FINDING OF NO SIGNIFICANT IMPACT

RUSH LINE BUS RAPID TRANSIT PROJECT ENVIRONMENTAL ASSESSMENT

SEPTEMBER 2021

SHEET NO.
15
OF
83

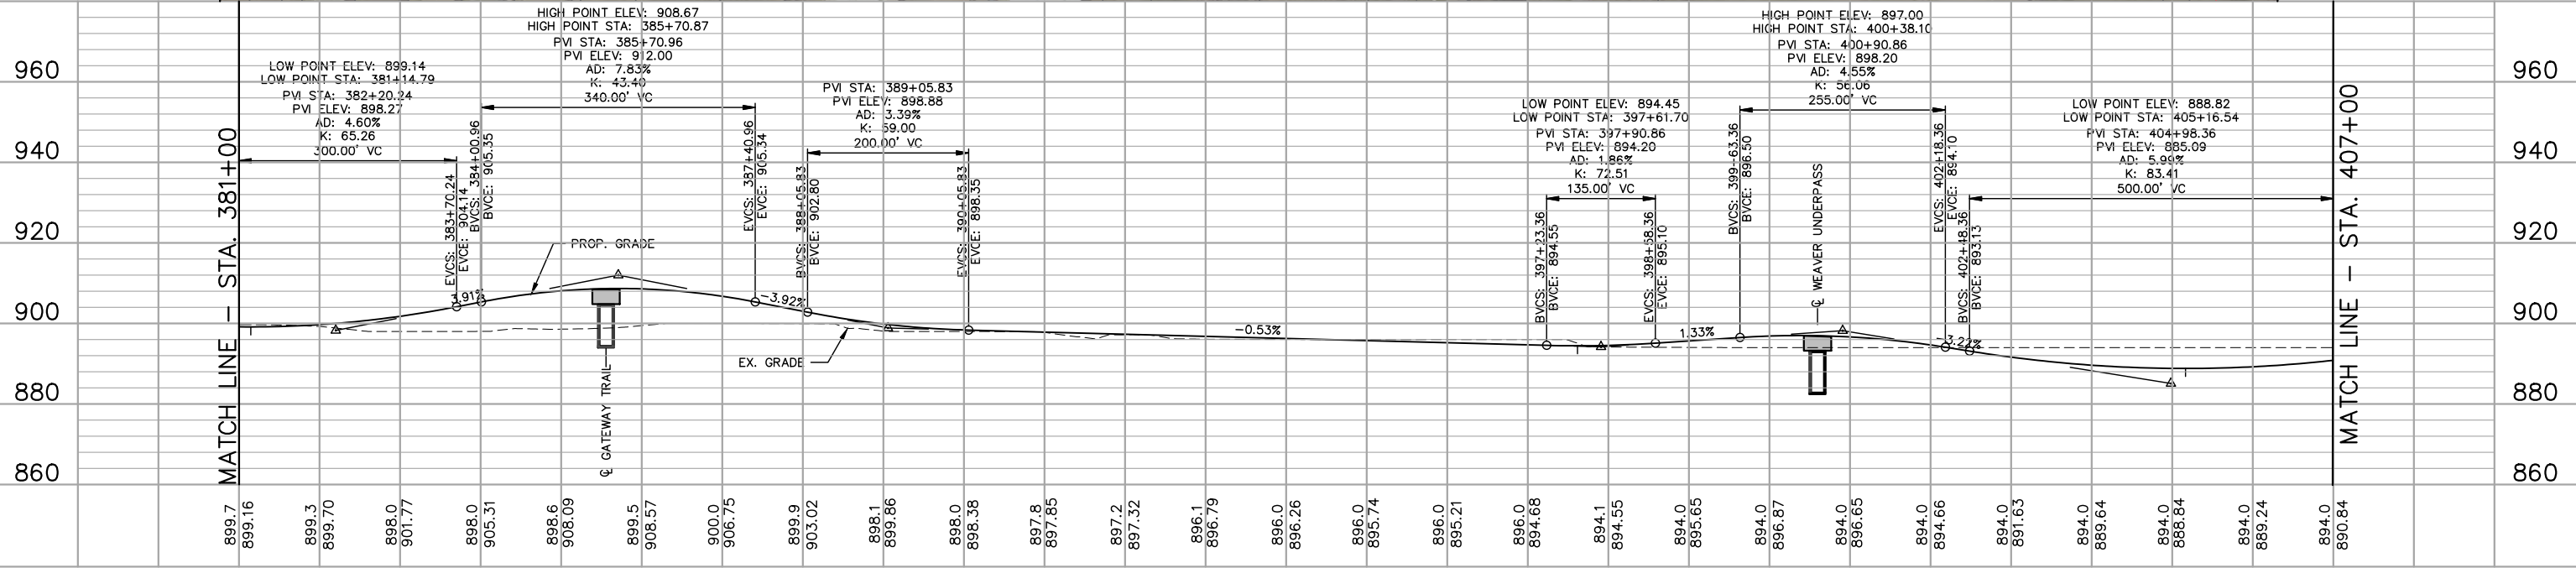
Comment	Response
Sheet 15: <ul style="list-style-type: none"> Plan for wayfinding here where the two trails meet. 	Wayfinding signage will be determined as design progresses.

Plan for wayfinding here where the two trails meet.

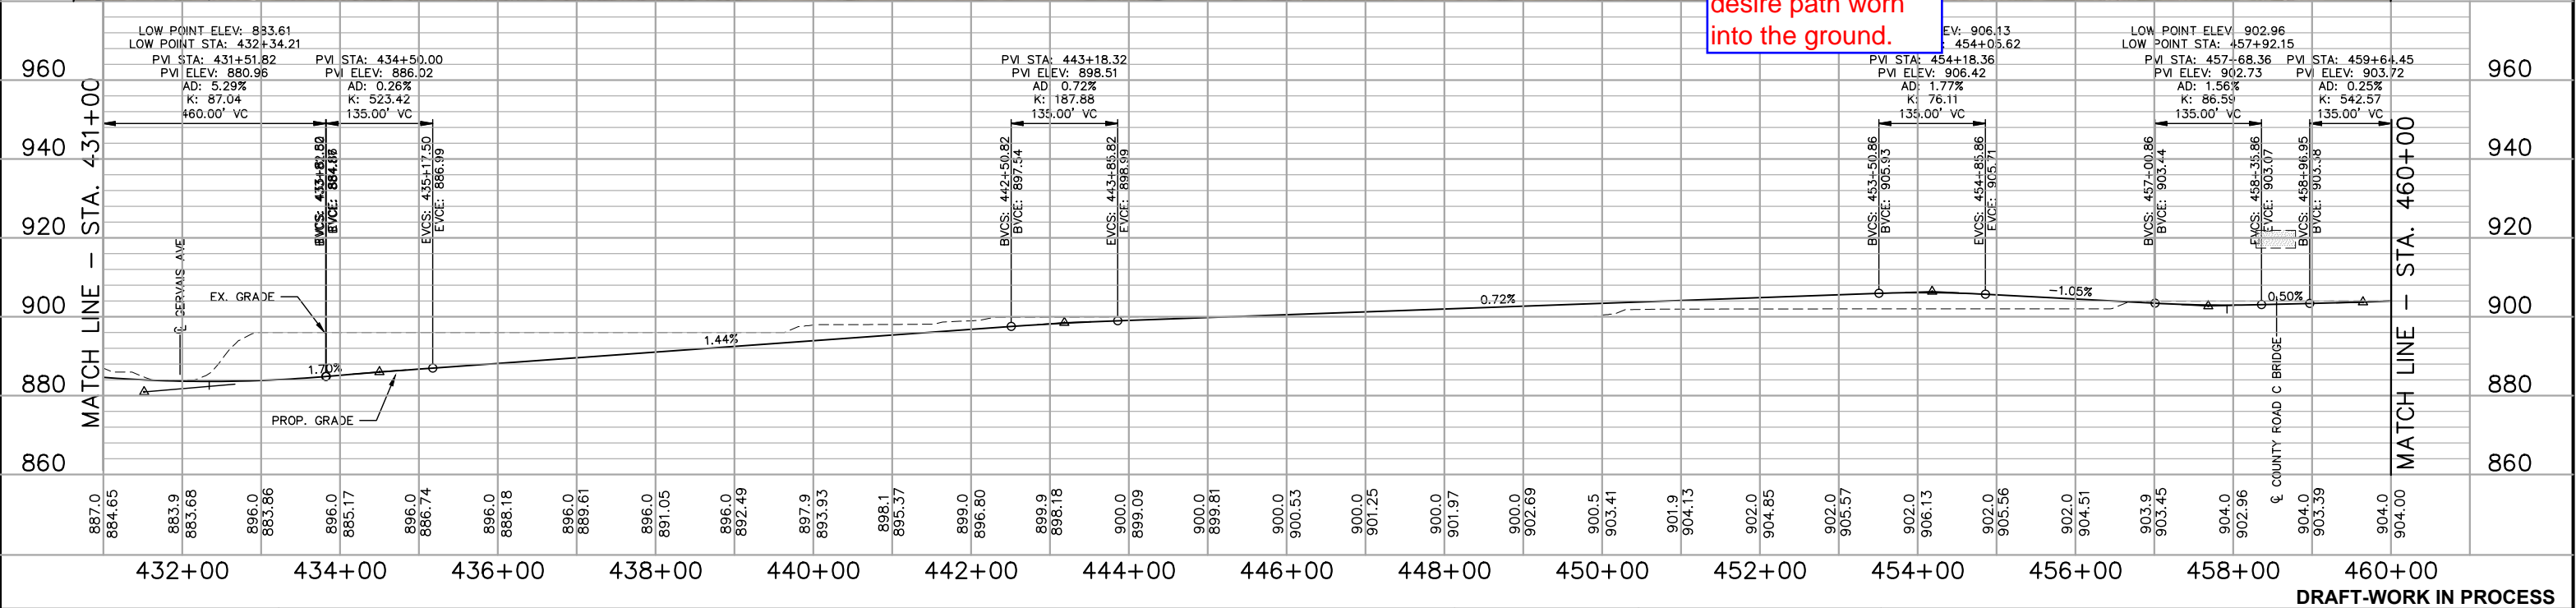
Sheet 17A: <ul style="list-style-type: none"> Consider including a connection here from the sidewalk. There already appears to be a desire path worn into the ground. 	The noted location is on private property. Project staff will work with adjacent property owners and the city of Maplewood on local pedestrian connections as engineering advances.

Consider including a connection here from the sidewalk. There already appears to be a desire path worn into the ground.

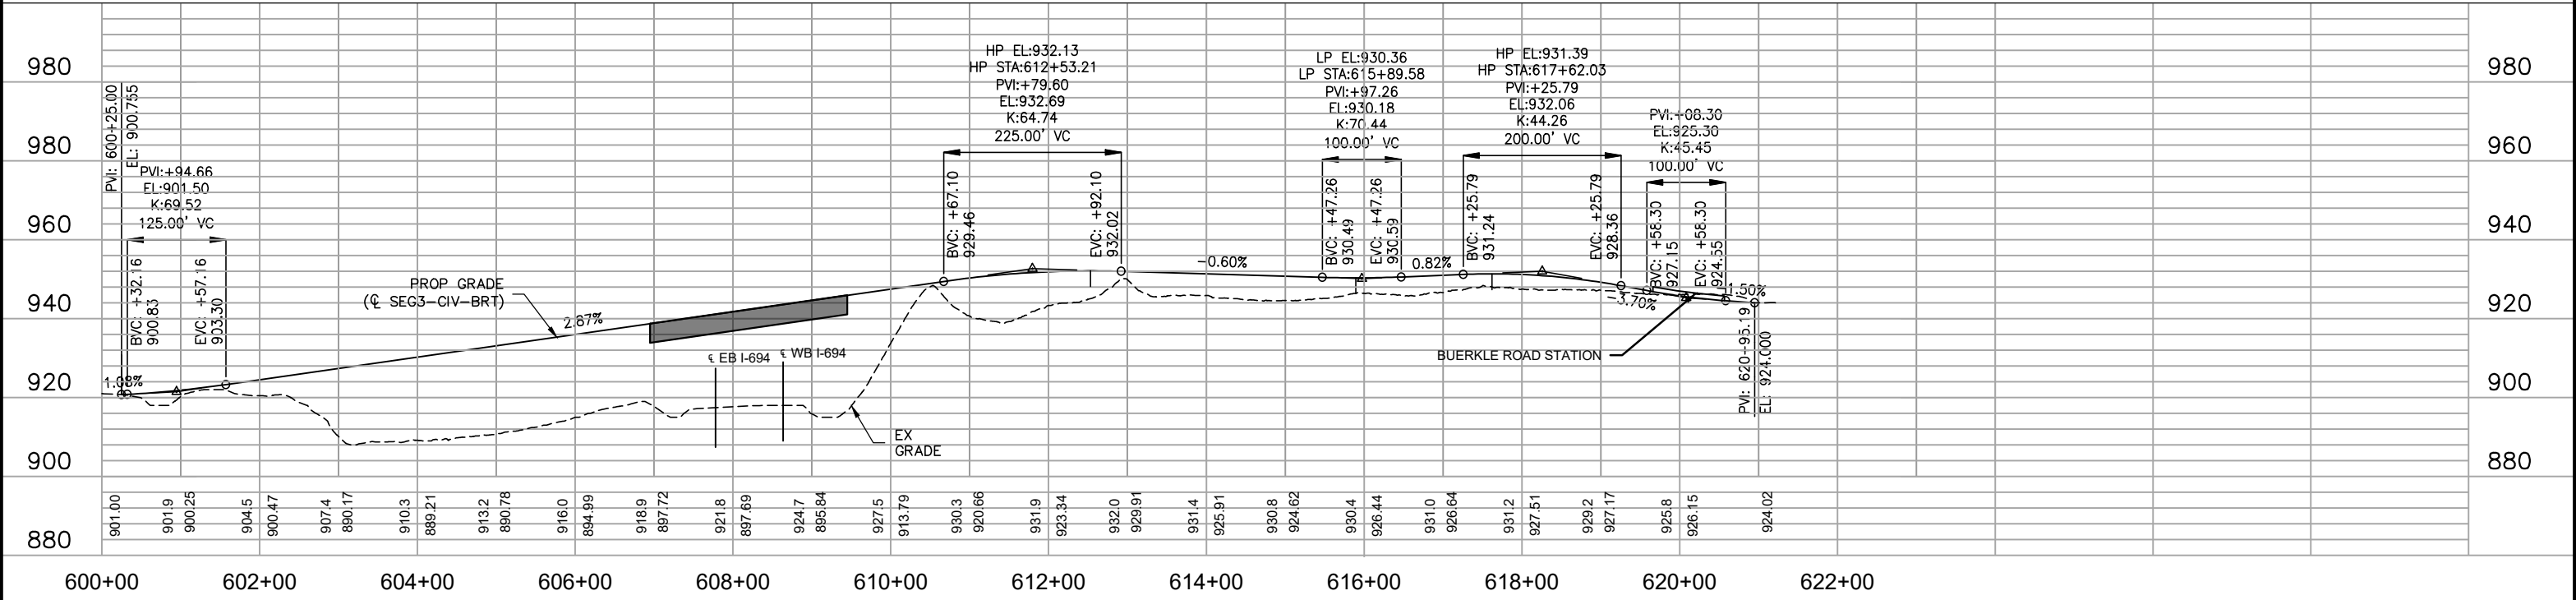
Sheet 21: <ul style="list-style-type: none"> Consider ped refuge in between traffic lane and dedicated bus lane. 	Right-of-way and design vehicle turning movement constraints limit the space available in this location and do not allow for a pedestrian refuge.

Consider ped refuge in between traffic lane and dedicated bus lane.

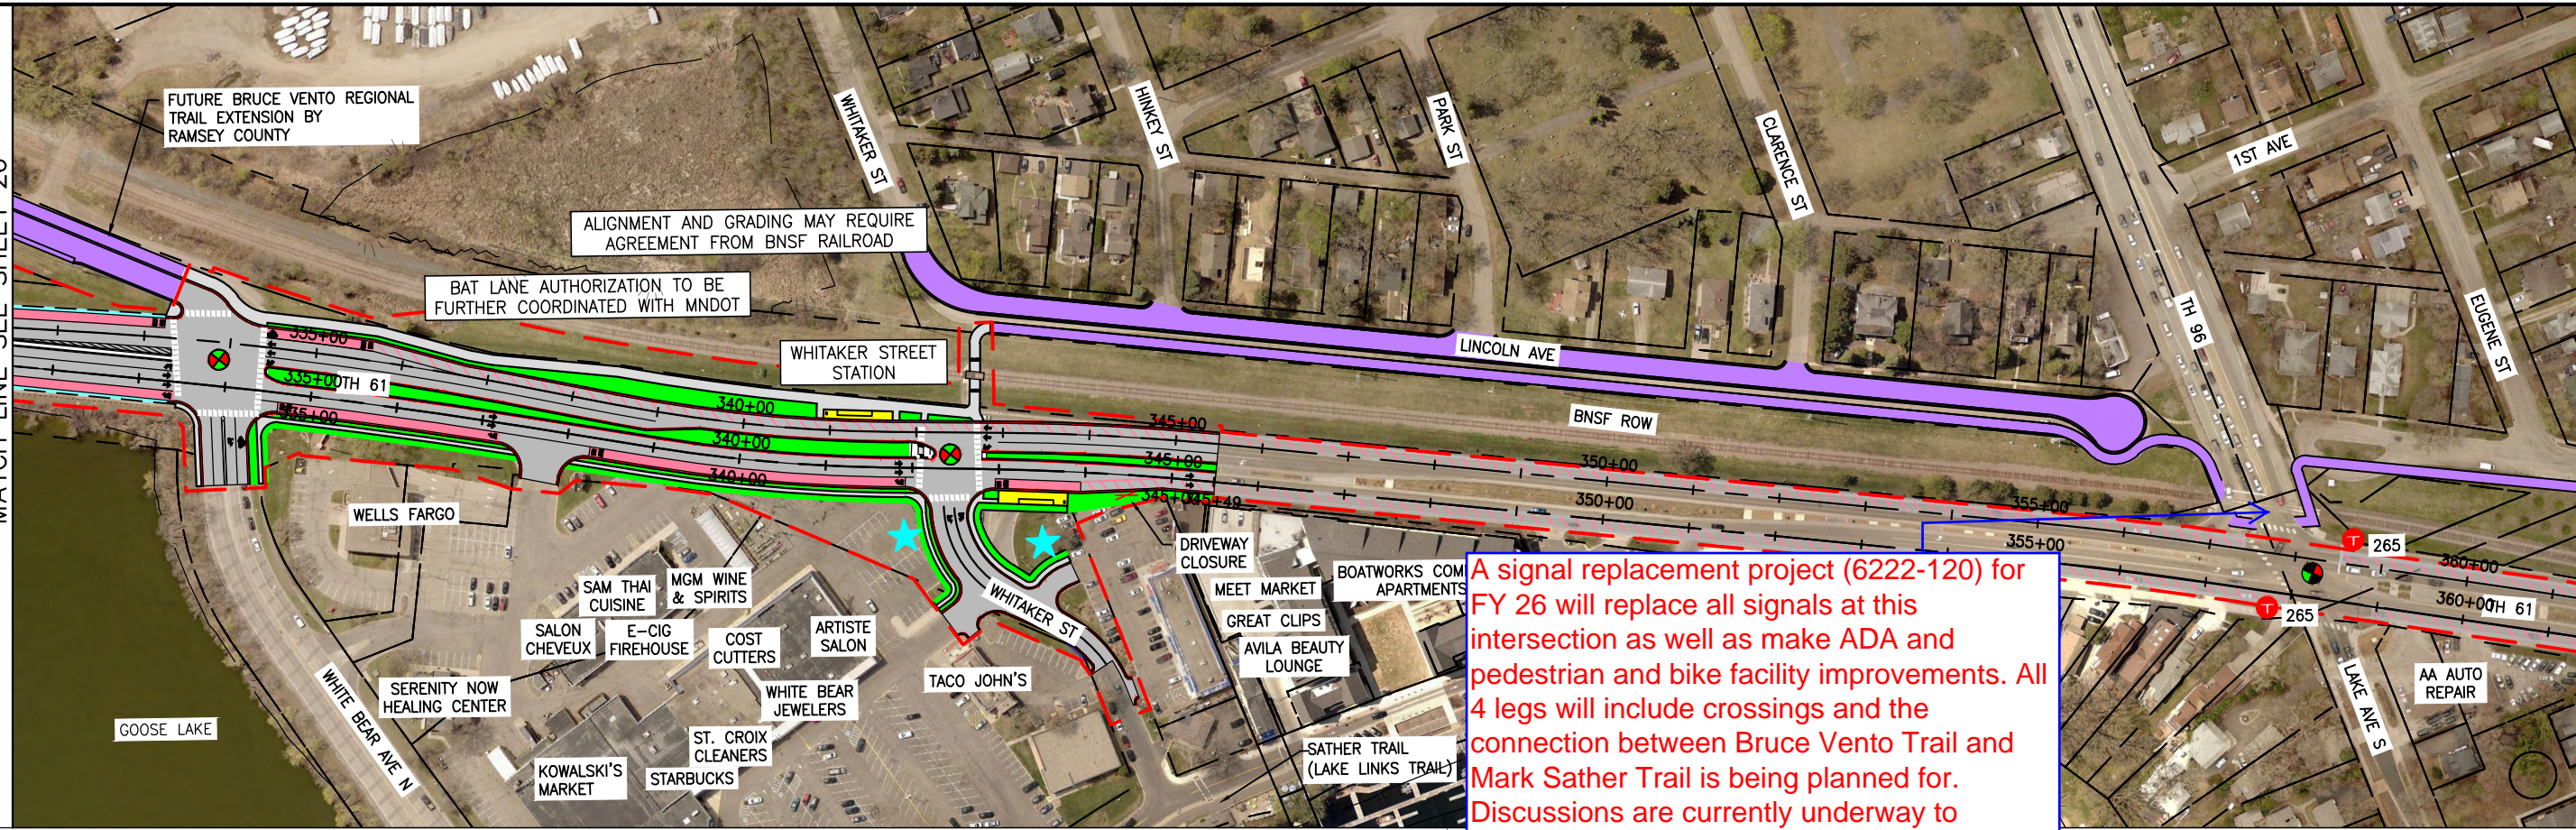
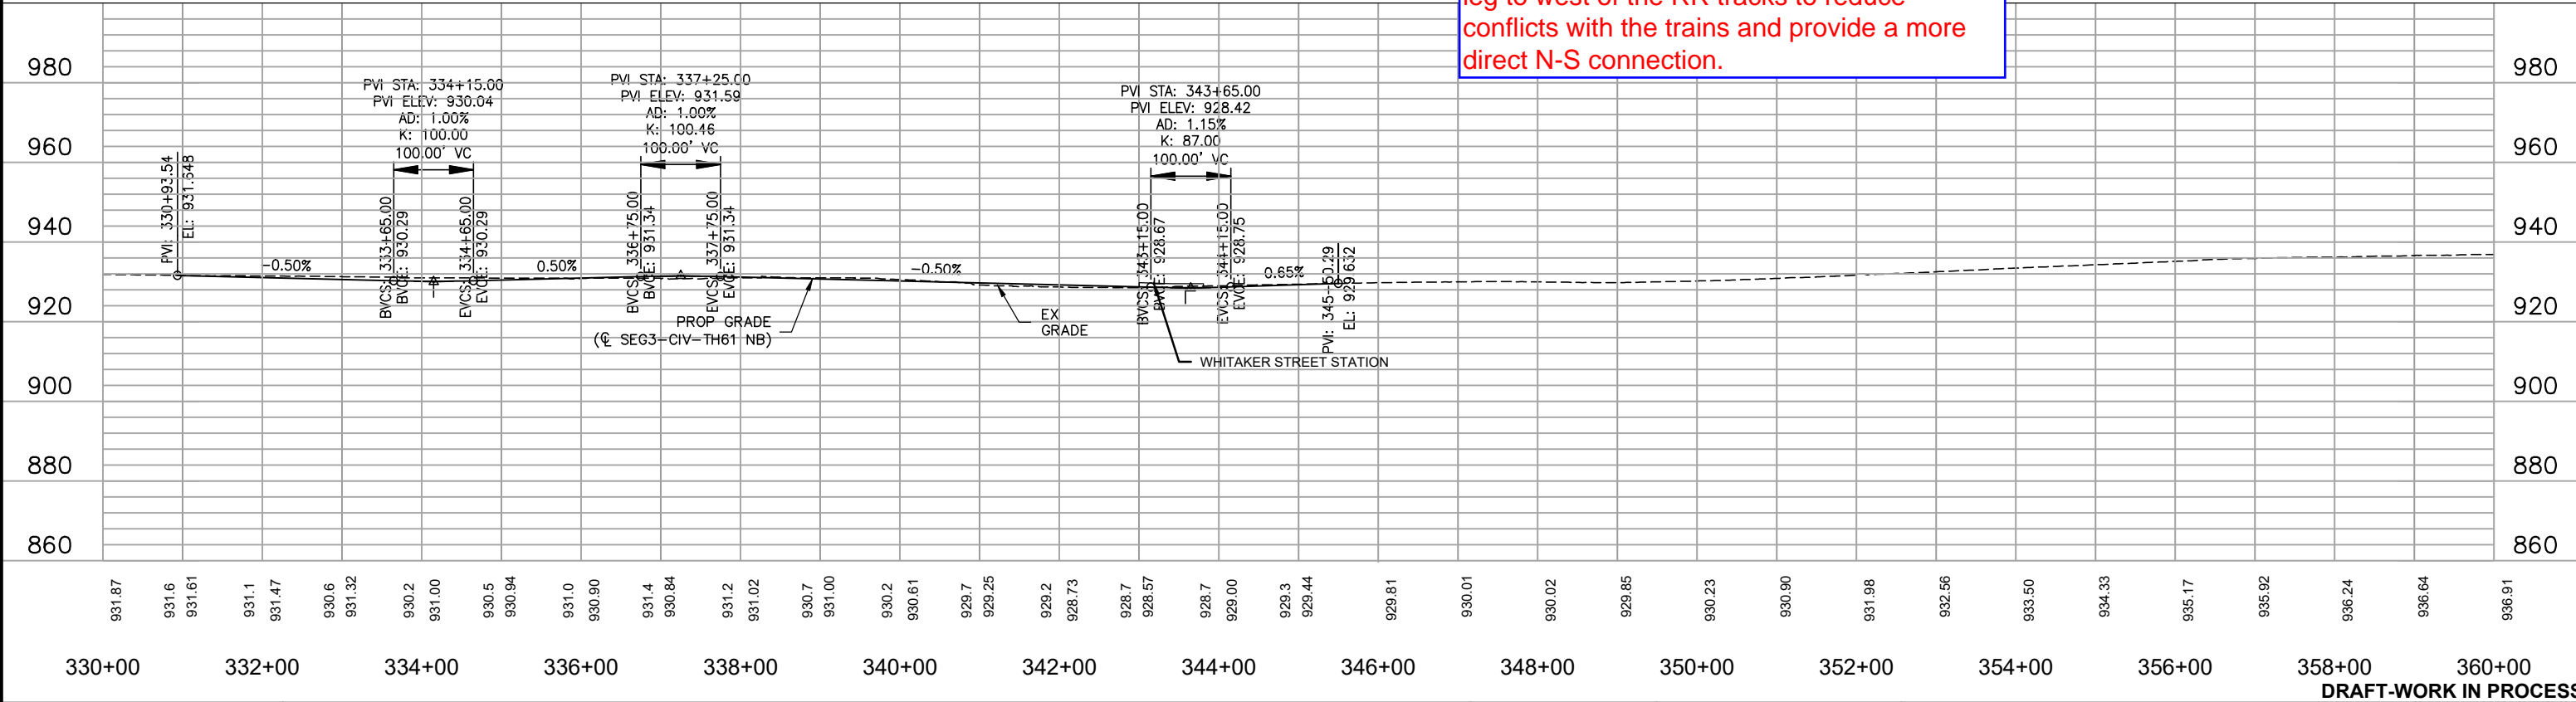
Sheet 27: <ul style="list-style-type: none"> A signal replacement project (6222-120) for FY 26 will replace all signals at this intersection as well as make ADA and pedestrian and bike facility improvements. All 4 legs will include crossings and the connection between Bruce Vento Trail and Mark Sather Trail is being planned for. Discussions are currently underway to potentially shift the N-S crossing of the west leg to west of the RR tracks to reduce conflicts with the trains and provide a more direct N-S connection. 	Project staff will coordinate with the Minnesota Department of Transportation on SP 6222-120 as engineering advances.
Water Resources	
Appendix F – Other Supporting Technical Information, Utilities Memorandum, Existing Conditions should also mention the Minnesota Department of Transportation as owning and maintaining Storm Sewer. The current writeup appears to miss this, despite noting that we did provide storm sewer information for their use for the EAW.	Comment noted. It is acknowledged that the Minnesota Department of Transportation also owns and maintains storm sewer within the study area. Project staff will coordinate with the Minnesota Department of Transportation regarding potential impacts to existing facilities as engineering advances.

A signal replacement project (6222-120) for FY 26 will replace all signals at this intersection as well as make ADA and pedestrian and bike facility improvements. All 4 legs will include crossings and the connection between Bruce Vento Trail and Mark Sather Trail is being planned for. Discussions are currently underway to potentially shift the N-S crossing of the west leg to west of the RR tracks to reduce conflicts with the trains and provide a more direct N-S connection.
